Letter No. 1764/NH-135-C

Subject: Proposed Reserved Forest Land to be diverted for Road Widening and Strengthening of Bhadewara to Dramandganj Road (NH-135C) in Km. No. 15.00 to 58.600 in District:-Prayagraj. (Online Proposal No: FP/UP/Road/157329/2022)

Reference: Office of Ministry of Environment, Forest & Climate Change, Integrated Regional Office, Lucknow, Letter no. 8B/UP/06/121/2023/F.C./164, dated 06.06.2023.

STRIP PLAN

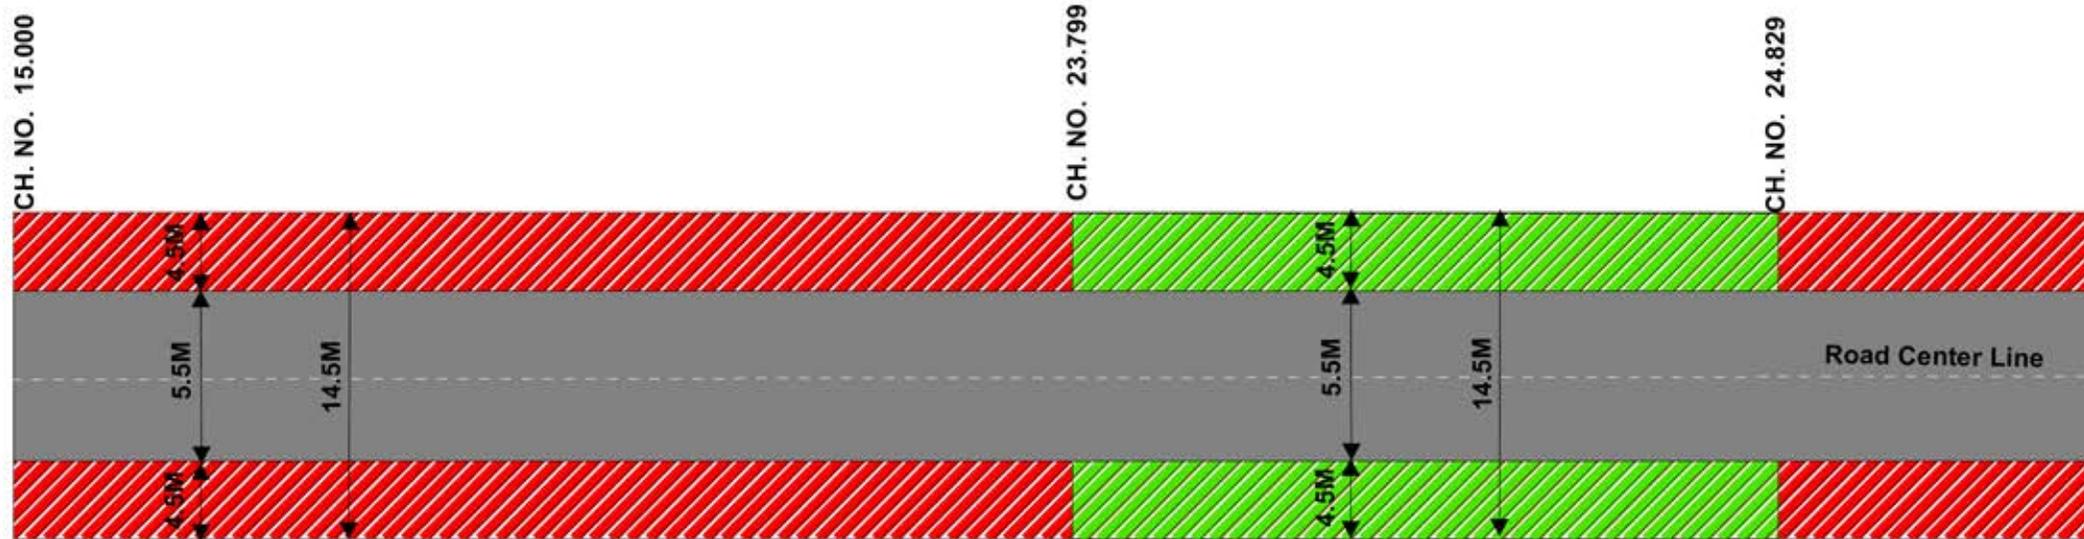
Sr. No.	Query	Reply
1	As per the Google earth imagery Canal and Railway crossing has been observed. Canal side and Railway side PF area has not been demarcated as a forest land in KML file. This needs clarification/rectification.	In this proposal Canal and Railway side area has been demarcated as non forest land because these crossings are not notified as forest land in gazette notification under Forest Conservation Act 1980.
2	NOCs from irrigation and Railway Department needs to be submitted.	As per the above condition no. 1, NOCs from irrigation and Railway Department is not applicable.
3	It is not clear from the proposal that what is the status of Widening before and after proposed alignment.	5.50m width of existing road is before widening and the width of road after widening is 10m + 2.25m of earthen shoulder on both sides of the road. And strip plan of proposed alignment is also attached.

STRIP PLAN

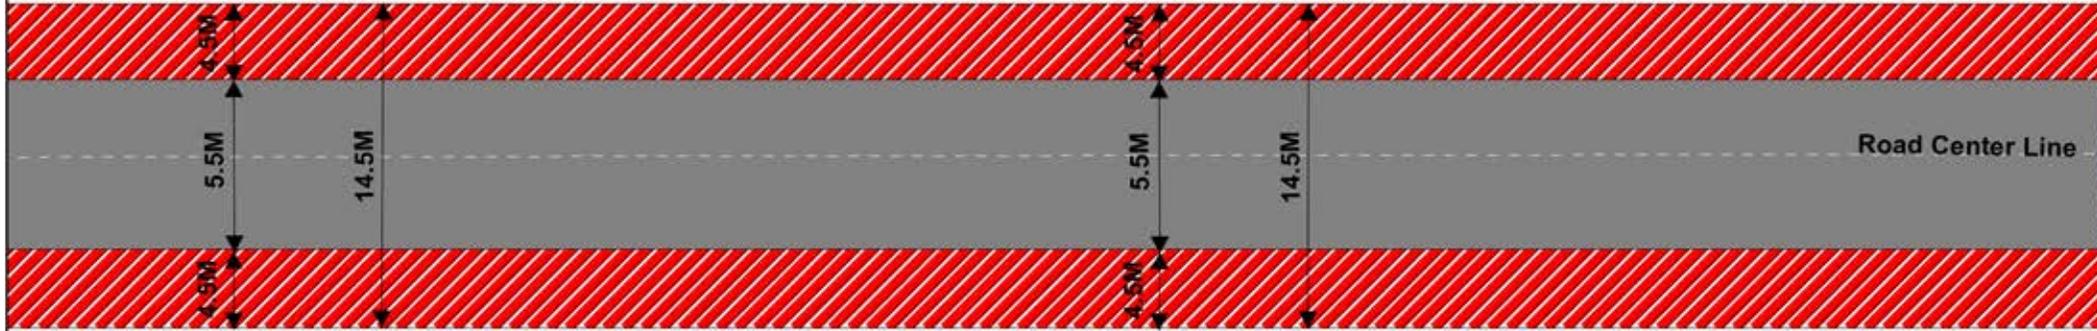
4	Details of existing ROW, proposed ROW and land width (ROW) availability of road side plantation needs to be submitted. Accordingly, scheme for roadside plantation needs to be submitted.	Existing ROW is = 5.5m (existing road width), proposed ROW is = 14.5m (Reserved forest land) and land width (ROW) availability of road side plantation is = 0 (since along Bhadewara to Dramandganj Road (NH-135C) from Km. No. 15.00 to 58.600 there is no Protected forest land under NHA ROW). So there is no remaining protected forest land for roadside plantation.
5	CA needs to be proposed on equivalent Non Forest Land.	As per the Guideline (FC-11/118/2021-FC) of Govt. Of India, MoEF&CC (FC Division) dated: 13.06.2023 Point No. v(b), if the diversion of forest land up to one hectare the equivalent non forest land is not applicable and this is proposal of State Government and in this proposal very small area 0.927 ha. reserved forest land is proposed for diversion so equivalent non forest land is not applicable as per above guideline therefore CA has been proposed on DFL.
